ADDENDUM NUMBER: ONE

**PROJECT: DND Tenant Fit - Up
REGINA, SK**

**SECURE ROOM DUCT OPENING
SECURITY BAR DETAILS**

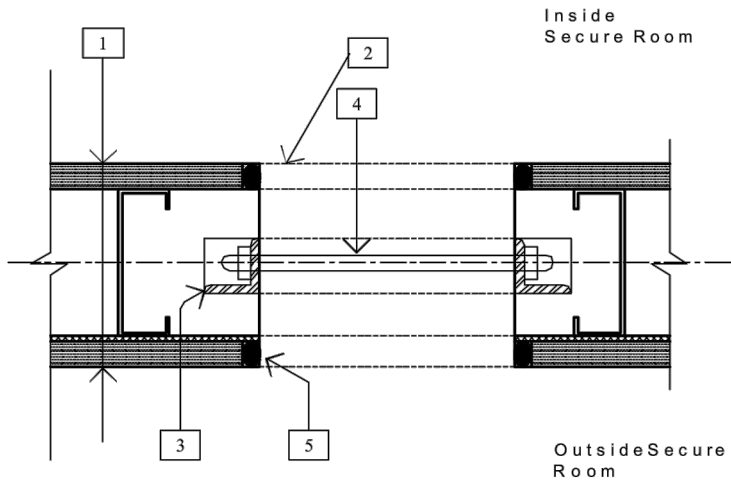
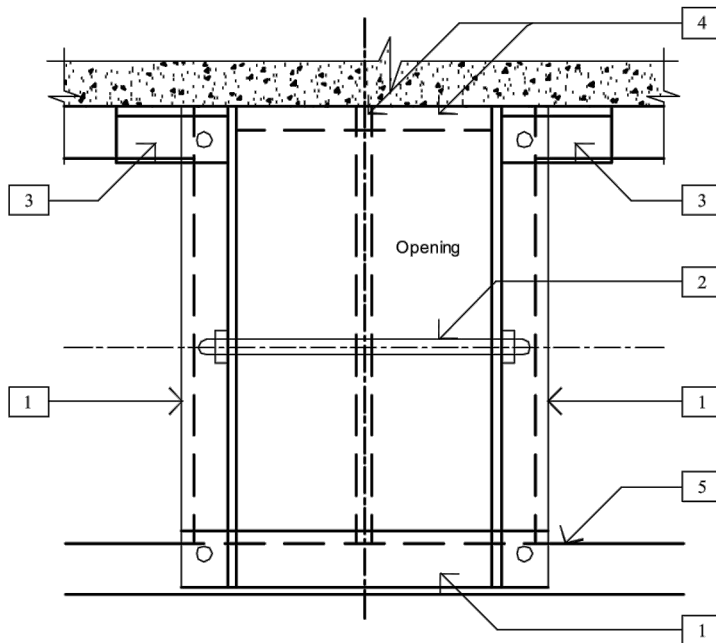
A1-2 REF. DRAWING M3.2

.1 “Add the following note: “Existing and new ductwork larger than 150mm penetrating the walls of Secure Rooms 105, 114 and 115 must have security bars installed in accordance with Drawing M3.2R1. This includes the following ducts: one existing 550x200, one existing 500mm, four existing 200mm, two new 200mm, one new 150mm, two new 250x200 & one new 300x250. Refer to drawing M3.2R2 for revisions to facilitate installation of security bars”
